HISTORIC AND DESIGN REVIEW COMMISSION

July 06, 2016

HDRC CASE NO: 2016-235
COMMON NAME: Marking Luther King Park
ADDRESS: 3503 MARTIN LUTHER KING DR
LEGAL DESCRIPTION: NCB 10677 P-5A, GIS 80.38 AC
ZONING: R4
CITY COUNCIL DIST.: 2
APPLICANT: Johnny Clayton/HALFF
OWNER: City of San Antonio
TYPE OF WORK: Conceptual approval for Martin Luther King Park
REQUEST:

2 PERSPECTIVE: MOUNMENT - HOUSTON ST.
Scale: NTS

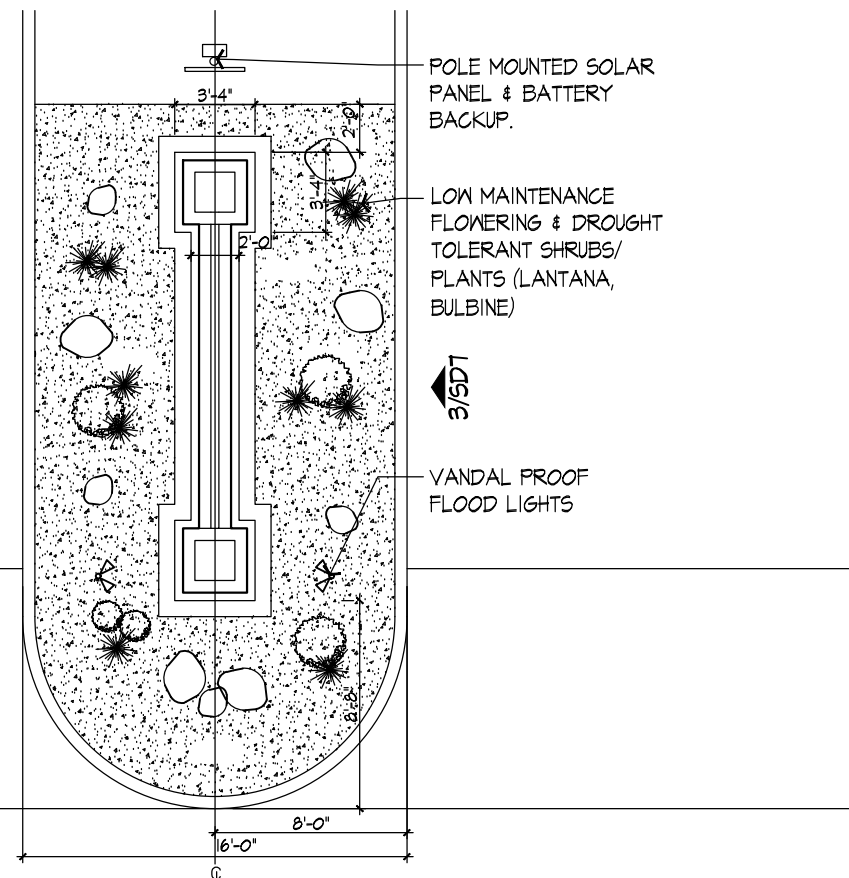
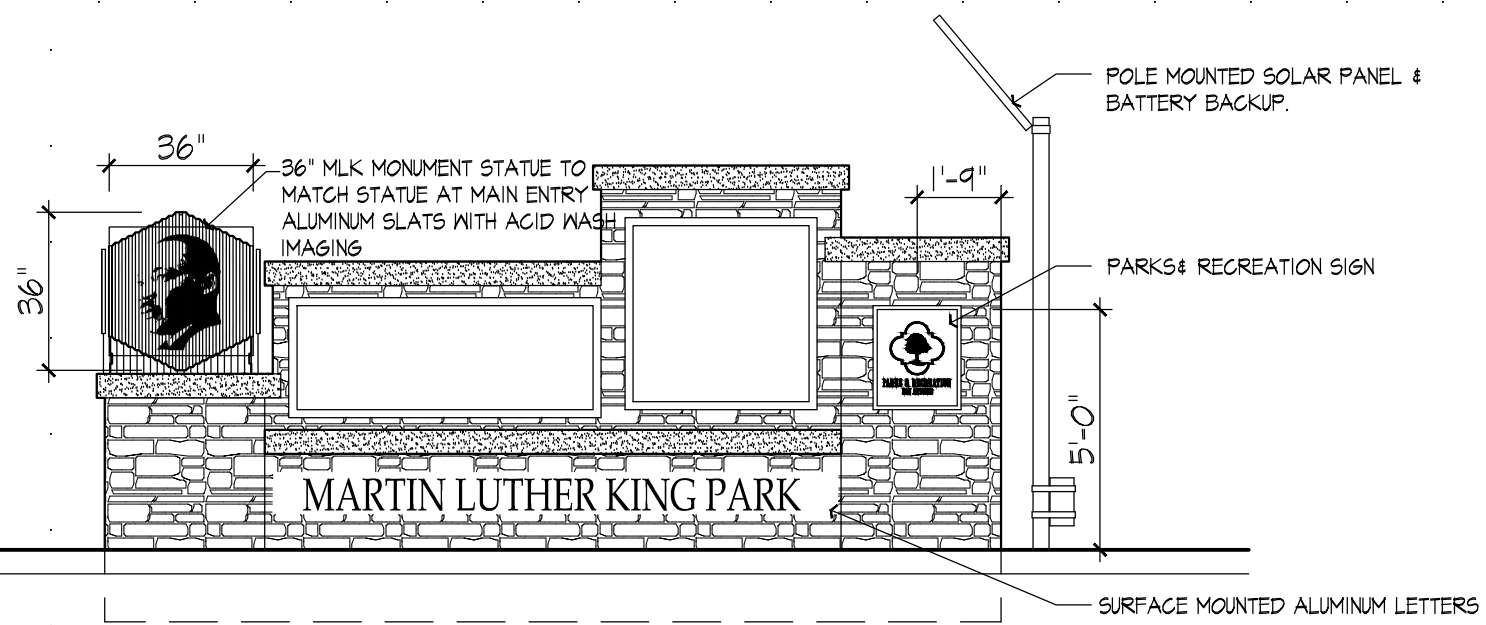
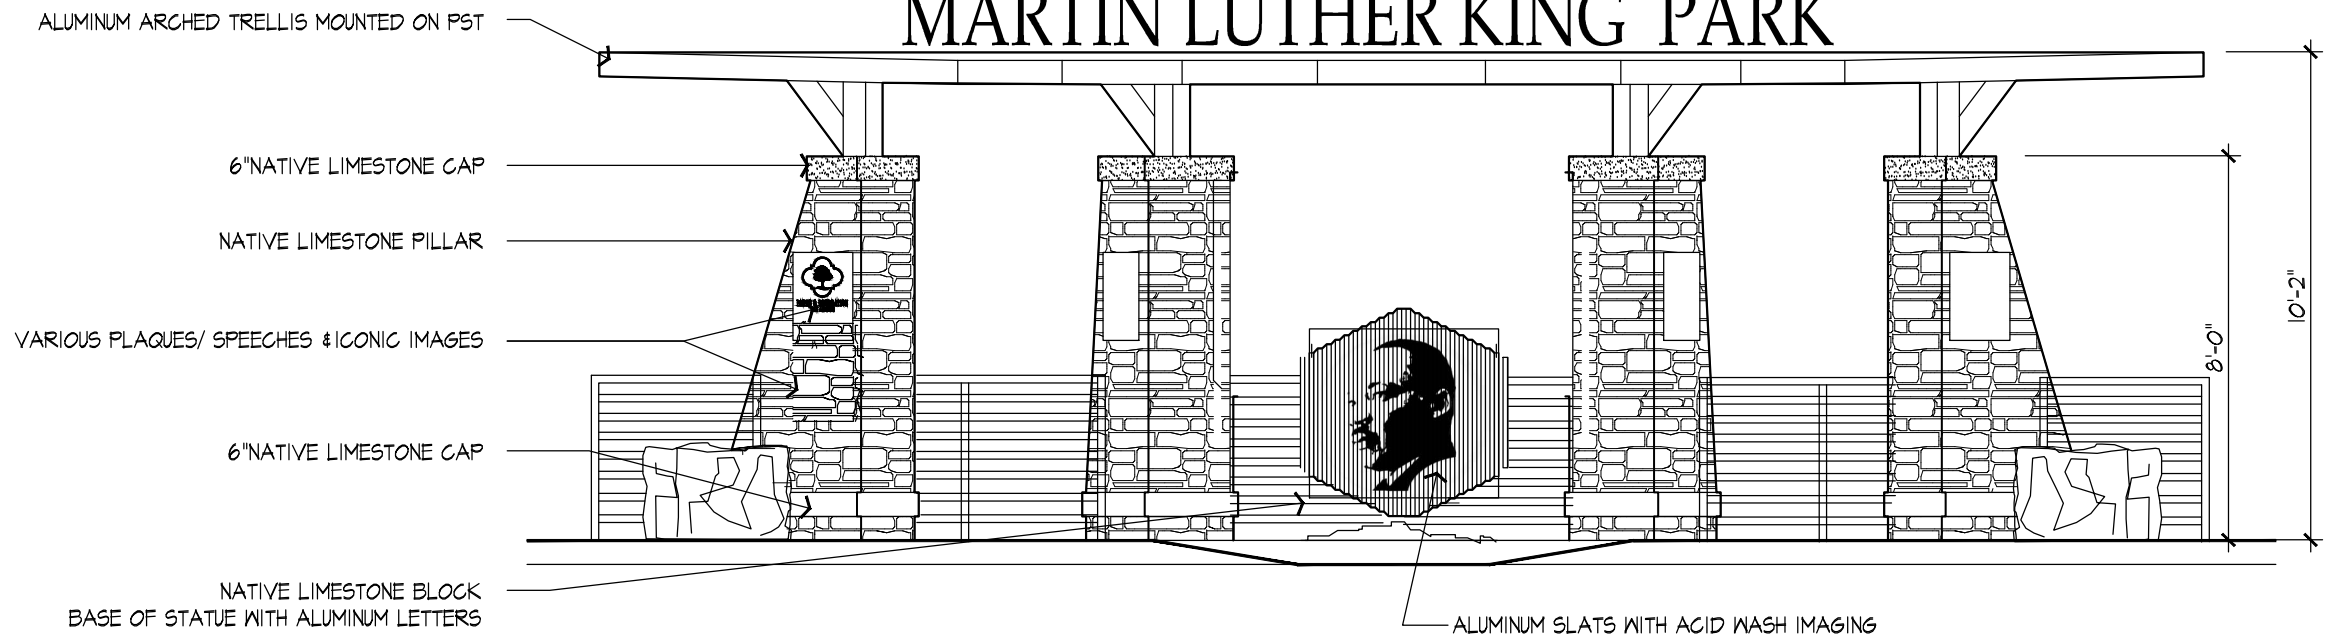
- d. The proposed monument at the North entrance off Houston St will be made of stone, with surface mounted aluminum letters, and 6 square foot monument statue made of aluminum slats with acid wash imaging. This monument is consistent with the UDC Sec 35-642(b)(7).

Staff recommends approval as submitted based on findings a through f.

1 MONUMENT 'A' ELEVATION
Scale: 1/4" = 1'-0"

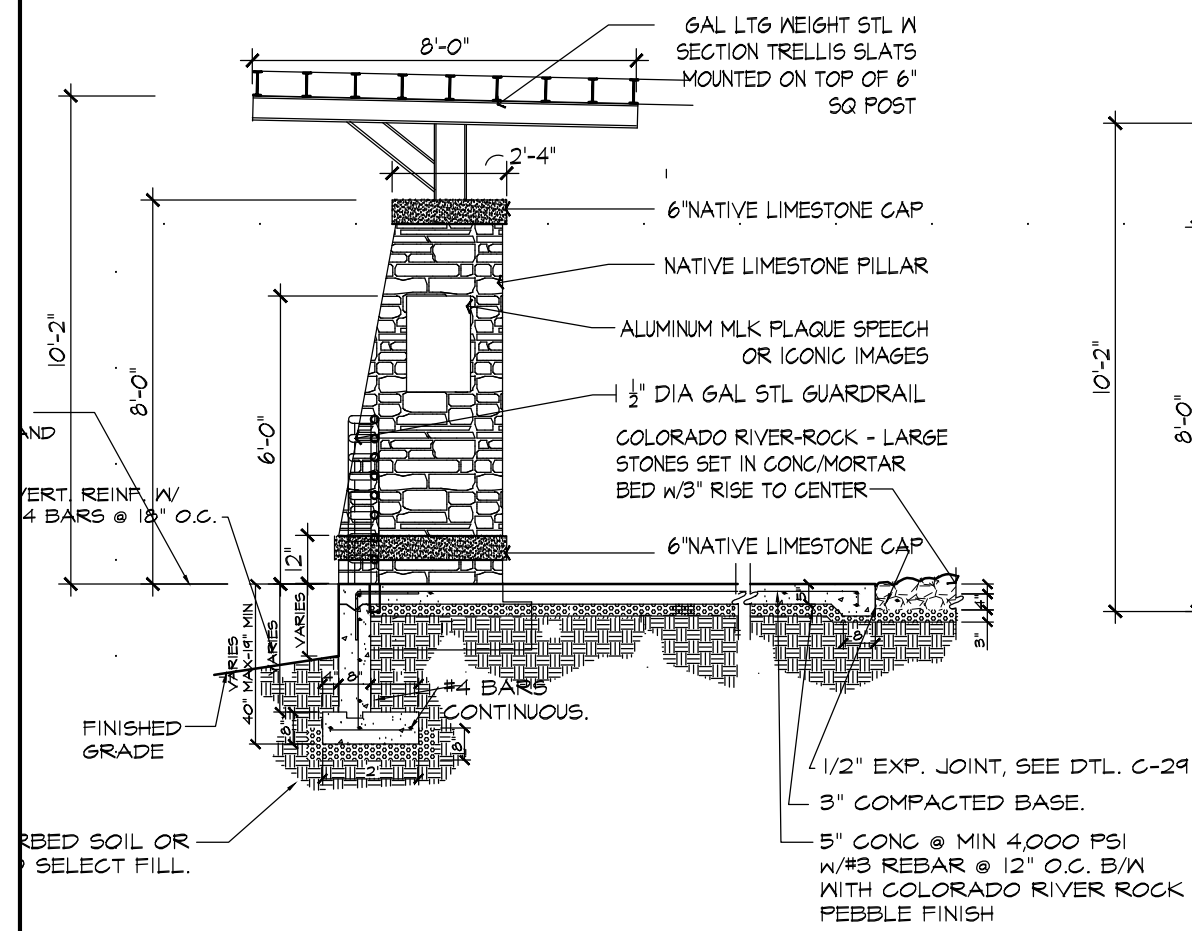
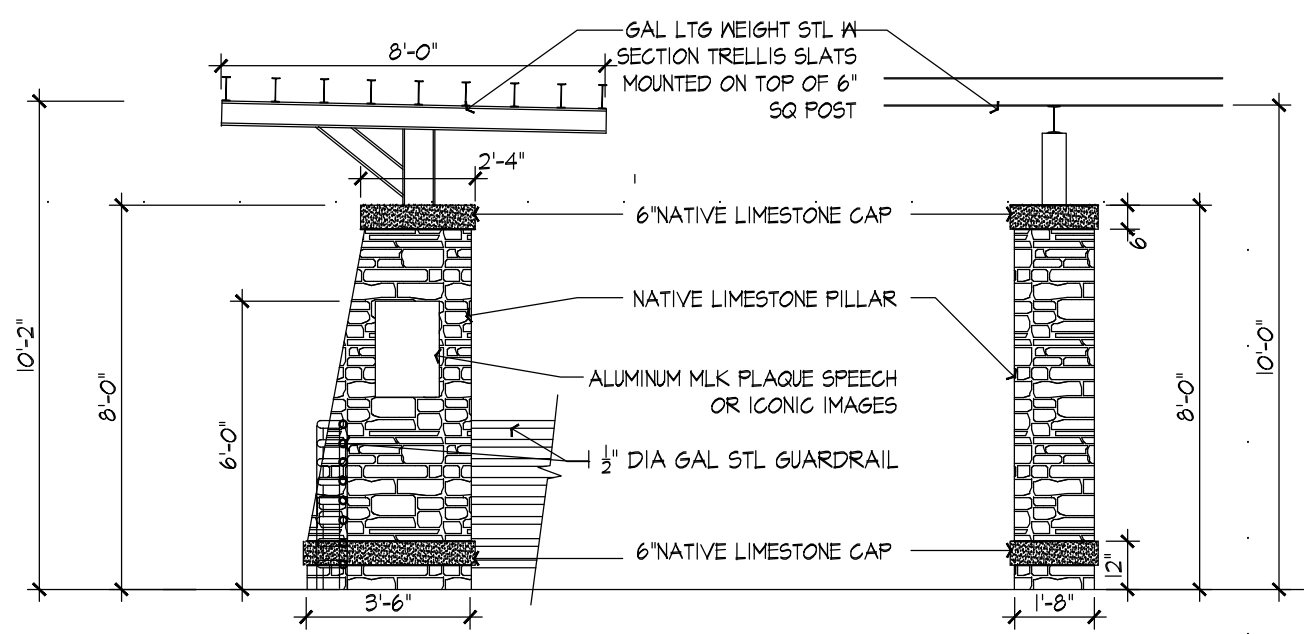
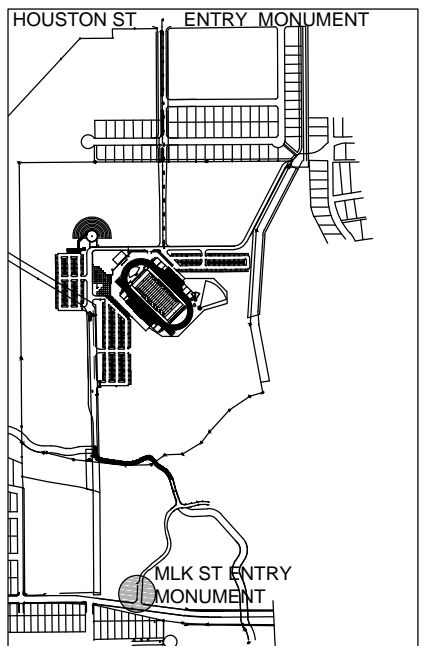
- a. Currently, there is a metal directional sign on the right corner of the south entrance. The proposed replacement monument, noted as Monument A at the south entrance, on the right side will be stone columns, a wood trellis, 10'-2" tall, and have a translucent metal representation made of aluminum slats and an acid wash imaging of Martin Luther King Jr on a stone pedestal. This monument is consistent with the UDC Sec 35-642(b)(7).

**PLAN DETAIL:
MONUMENT WALL - MLK ST. "B"**
Scale: 1/4" = 1'-0"

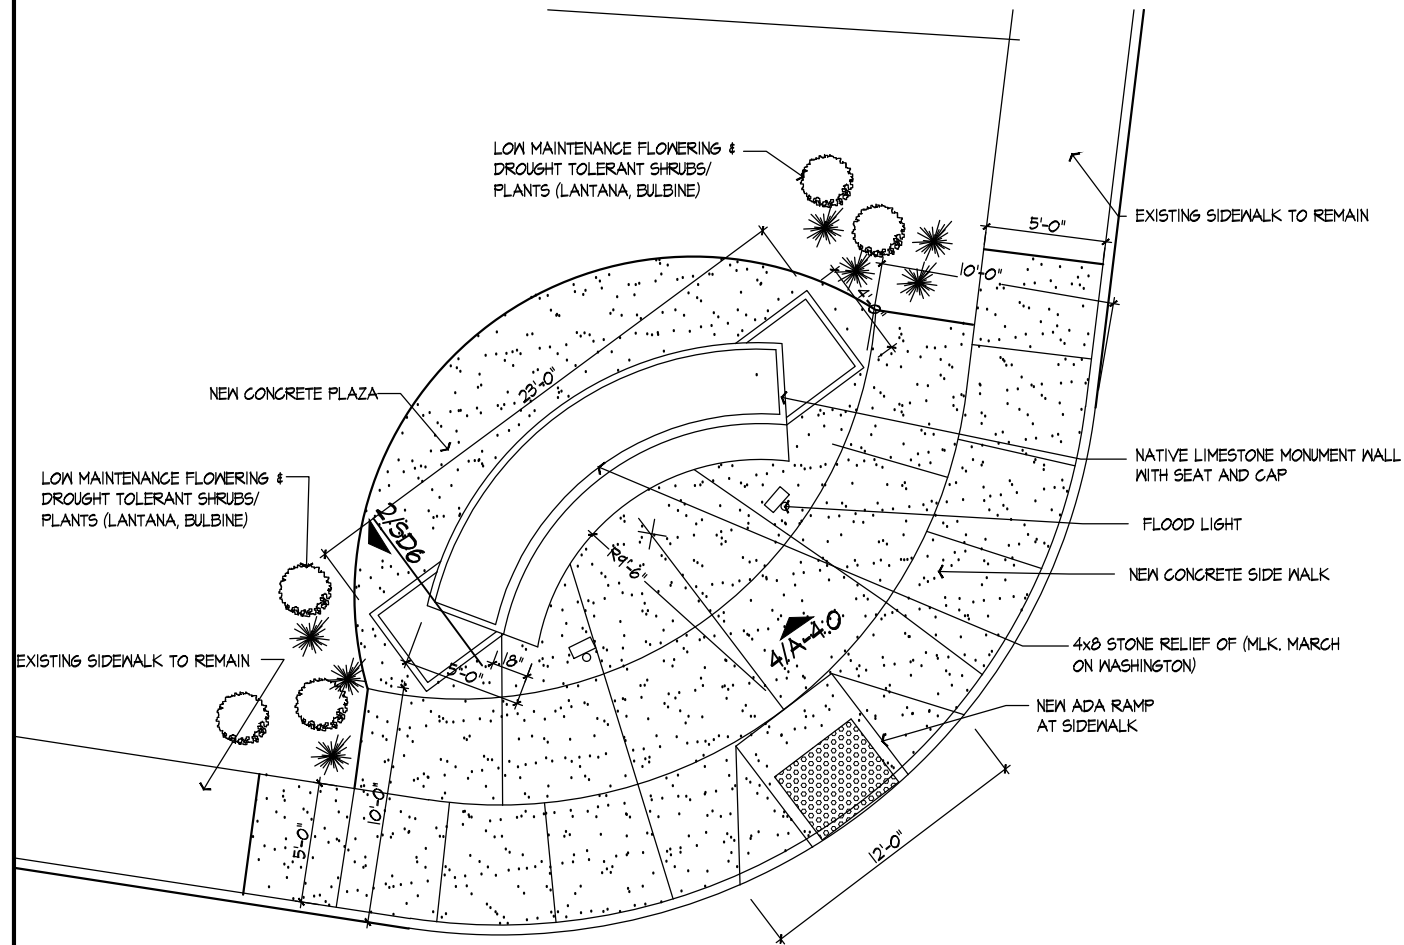
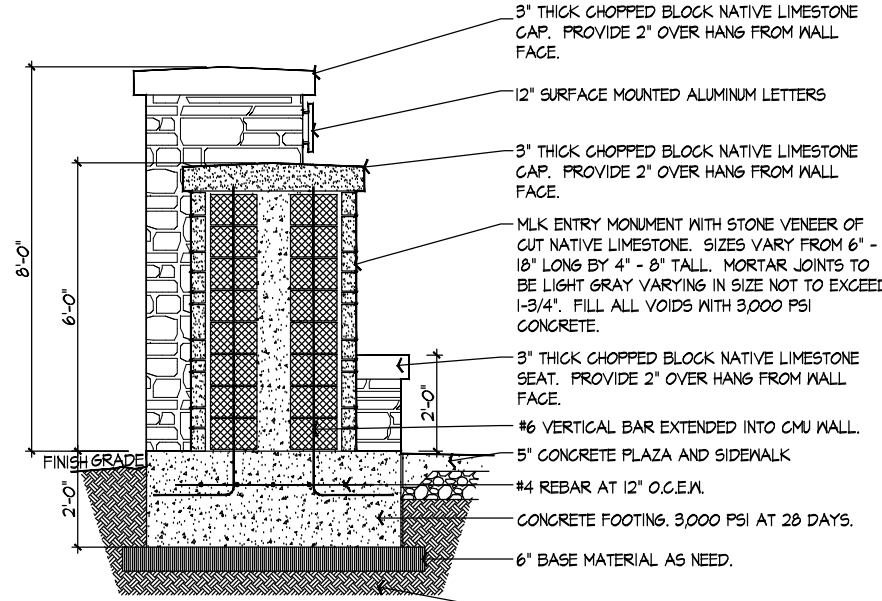
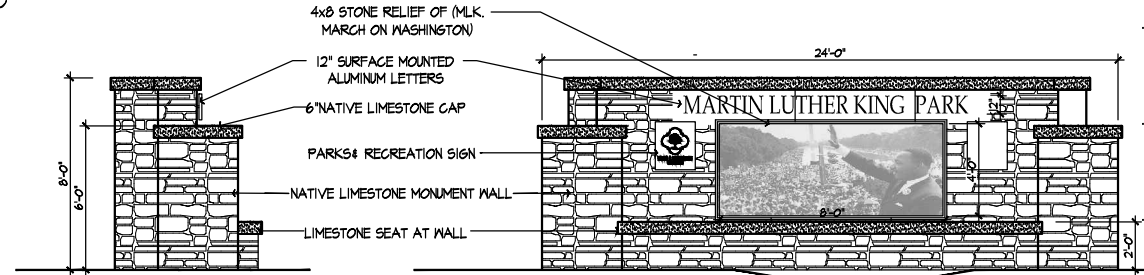
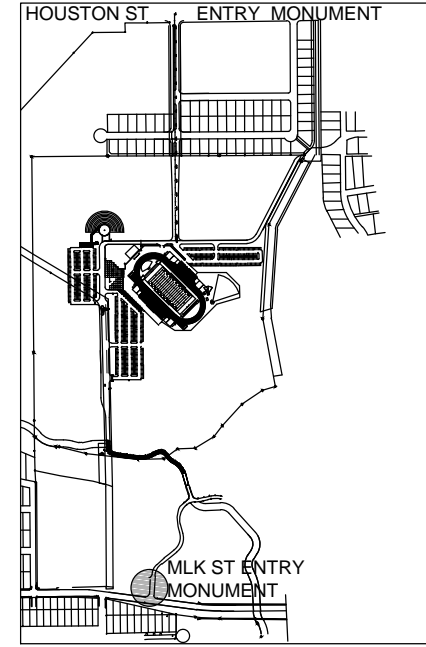
- b. Currently, there is a rounded retaining wall, metal bench, and Freedom Bridge marker. The proposed replacement monument with signage at the south entrance, on the left side will be curved, with planters and a 4' x 8' stone relief of MLK March on Washington. This monument is consistent with the UDC Sec 35-642(b)(7).

- c. The Freedom marker at the southeast corner of the entrance from Martin Luther King Dr. will be mounted to the new monument structure which will place it in close proximity to its original location.

ILLUMINATION LAYOUT

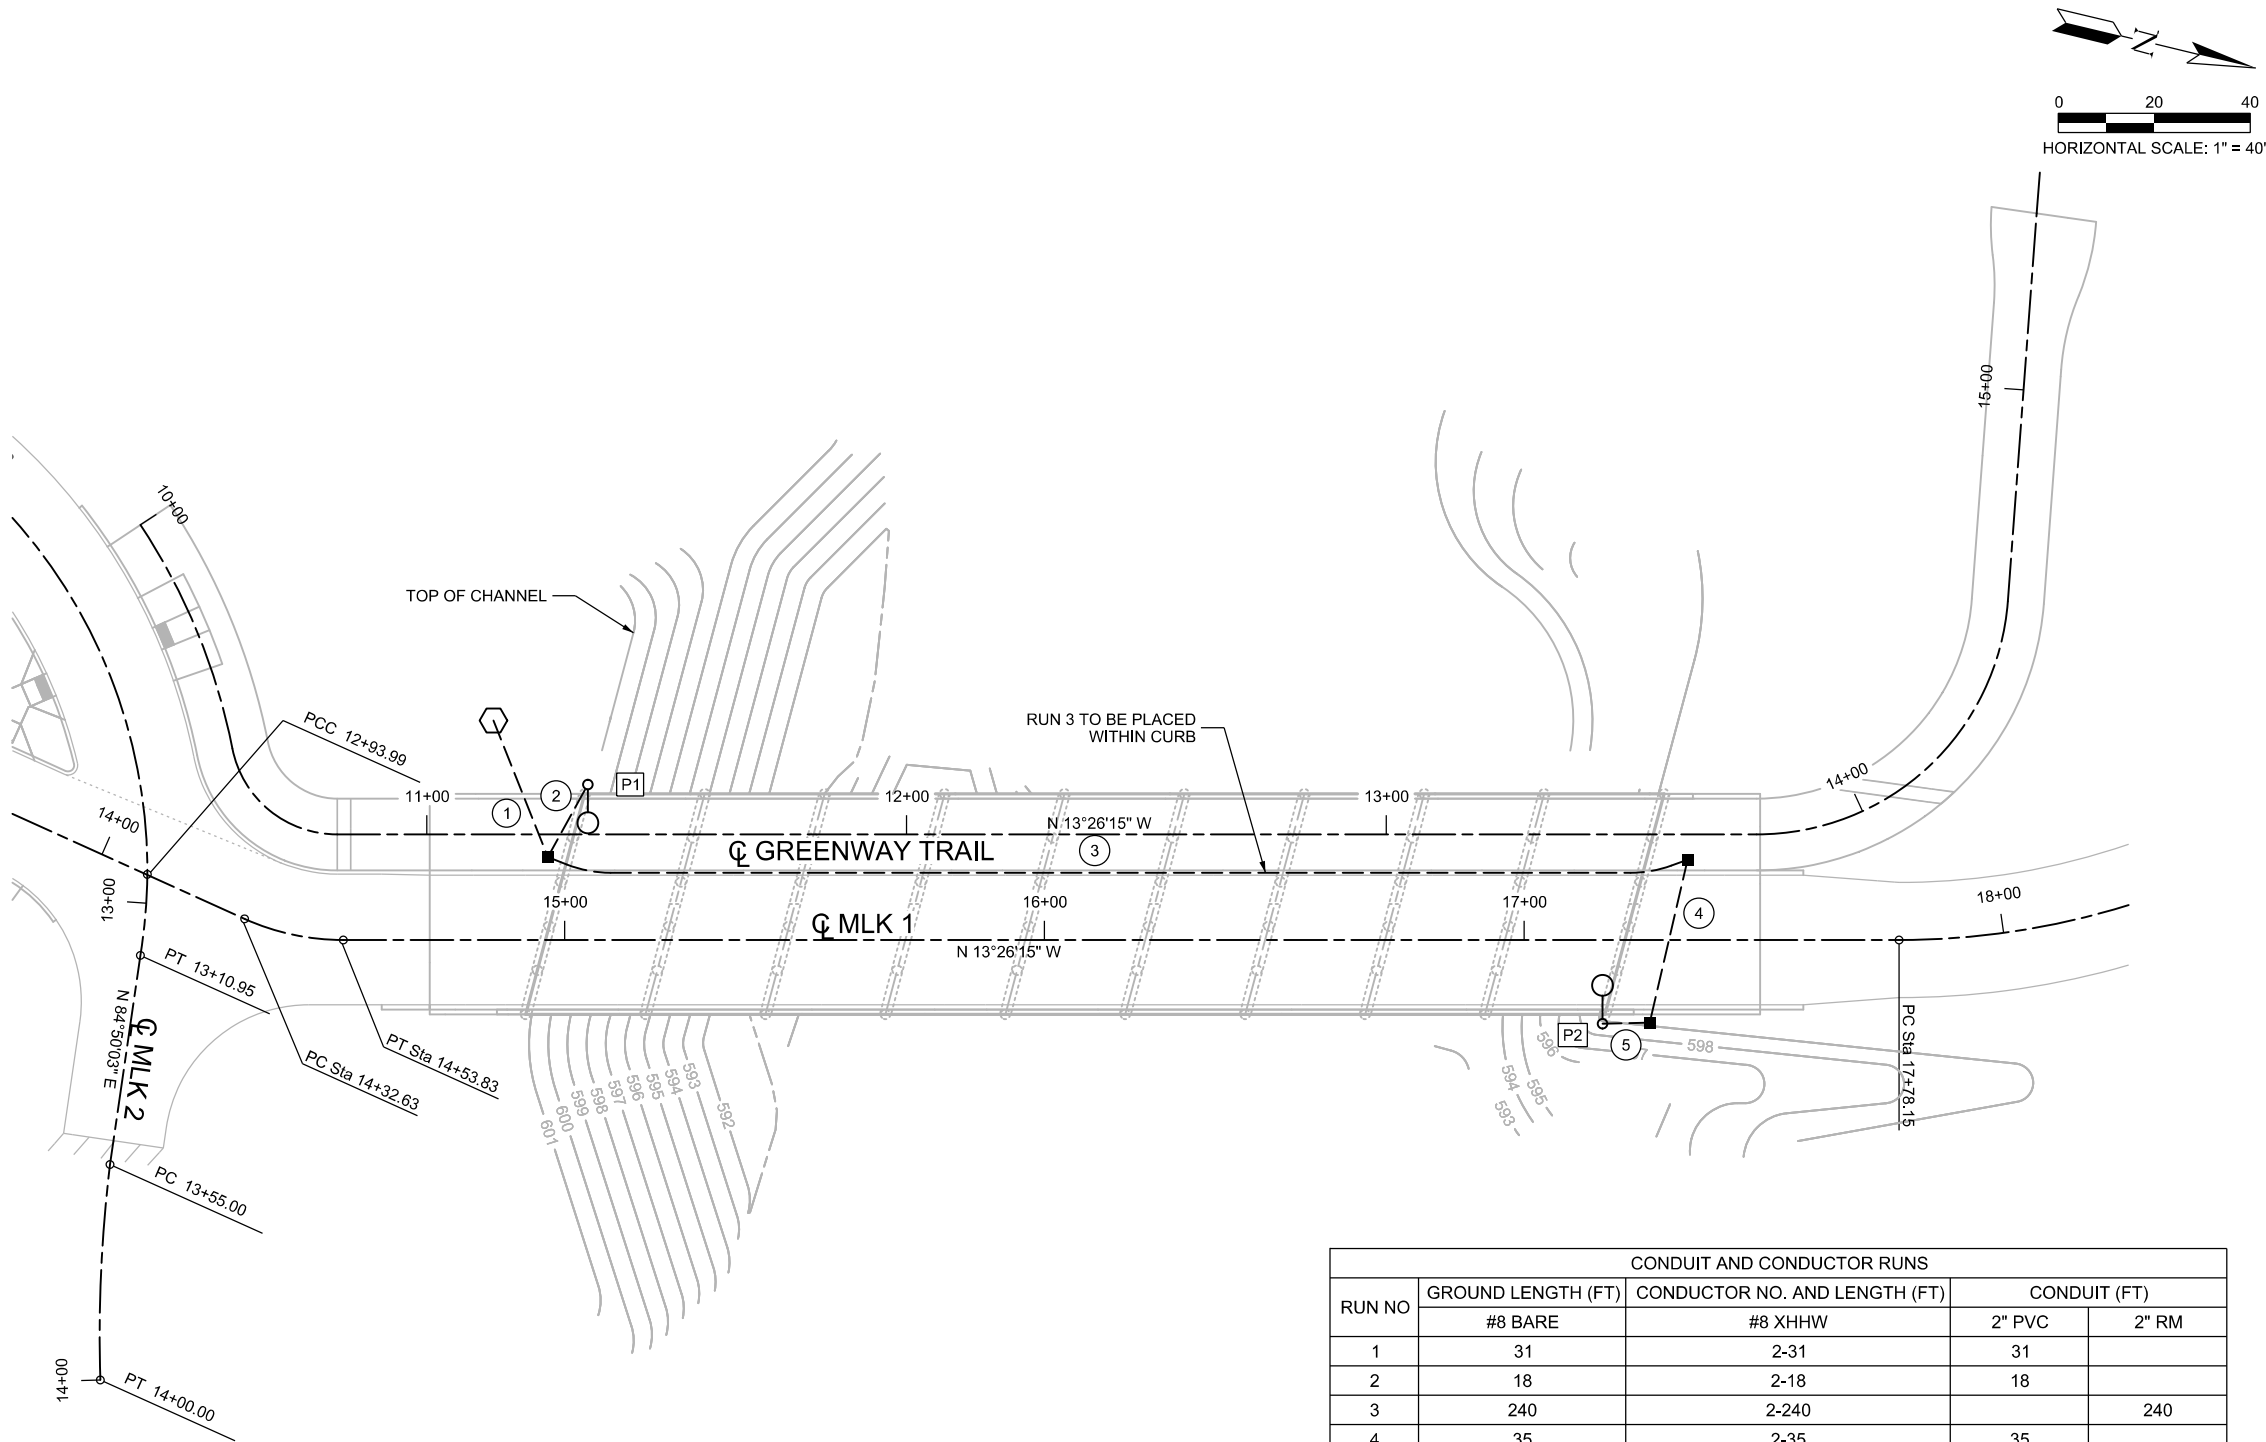
- f. The proposed improvements to the Salado Creek Bridge greenway are appropriate for the location, compatible with the landscape, and improve accessibility to the park. This is consistent with UDC Sec 35-642(b).
